Regarding: Preliminary shield for a Signa Artist IPM  
Location: Jupiter Medical Center in Jupiter, FL

Re: Shielding Design for CT Scan Room 1051 at Avenir Micro Hospital - PBG

Re: Shielding Design for R/F Room 1065 at Avenir Micro Hospital - PBG

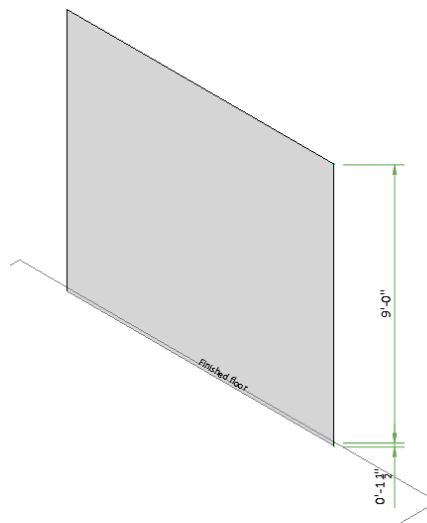
- 1) The layout was arranged so that the *unshielded* 5G field is contained to the magnet room except:
  - a) West

Note: The customer is responsible for restricting access to areas exceeding 5 Gauss, this can be accomplished by providing barriers, warning signs, or other access controls. Magnetic shielding can also be developed to reduce the fields

- 2) The information provided indicates that the floor-to-floor above spacing is 16'-0".
  - a) The *unshielded* 5G field does not enter the floor above.

We Estimate/ The requested containment can be achieved by using an M36 Silicon Room shield 1/8 in [3mm] thick on

- West wall of the room.
